Reference: U.S. Geological Survey TRIGA Reactor (GSTR), Docket 50-274, License R-113, Revision of Proposed Technical Specifications

Subject: Revision of Proposed Technical Specifications

**THE UNITED STATES GEOLOGICAL
SURVEY TRIGA RESEARCH REACTOR**

SEPTEMBER 2015

The reactor administration shall be related to the USGS and USNRC structure as shown in Figure 14.1.

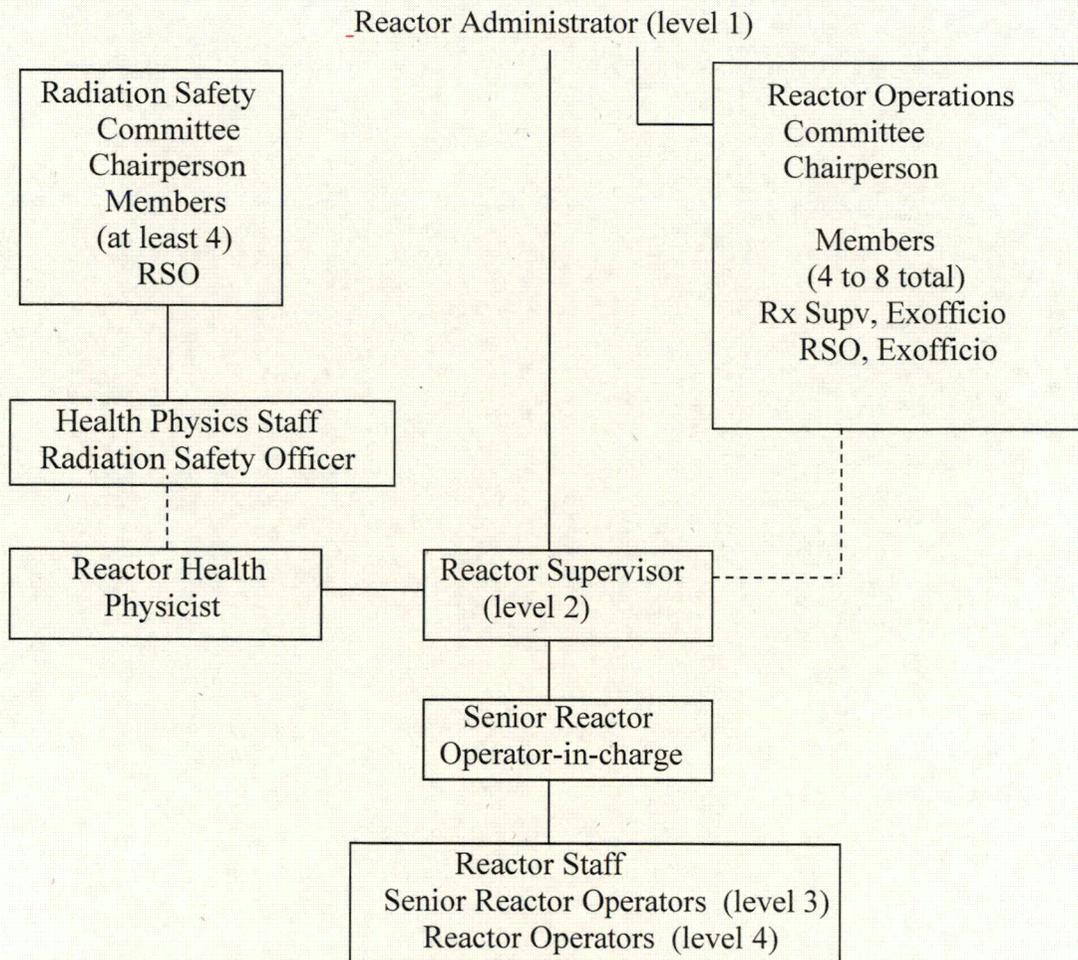
~~1. USGS Director (Level 1): The Director is accountable for ensuring that all regulatory requirements, including implementation and enforcement, are in accordance with all requirements of the USNRC and the Code of Federal Regulations.~~

~~a1.2.~~ Reactor Administrator (Level ~~21~~): The Reactor Administrator is responsible to the USGS Director and is responsible for guidance, oversight, and management support of reactor operations;

~~3b2.~~ Reactor Supervisor (Level ~~32~~): The Reactor Supervisor reports to the Reactor Administrator and is responsible for directing the activities of the Reactor Operators and Senior Reactor Operators and for the day-to-day operation and maintenance of the reactor;

~~4c3.~~ ~~Reactor Operator and Senior Reactor Operator~~ (Level ~~43~~): The ~~Reactor Operator and Senior Reactor Operators~~ report to the Reactor Supervisor and are primarily involved in the oversight and direct manipulation of reactor controls, ~~monitoring of instrumentation, and oversight and direct~~ operation and maintenance of reactor related equipment, and oversight of recovery from unplanned shutdowns; ~~and~~
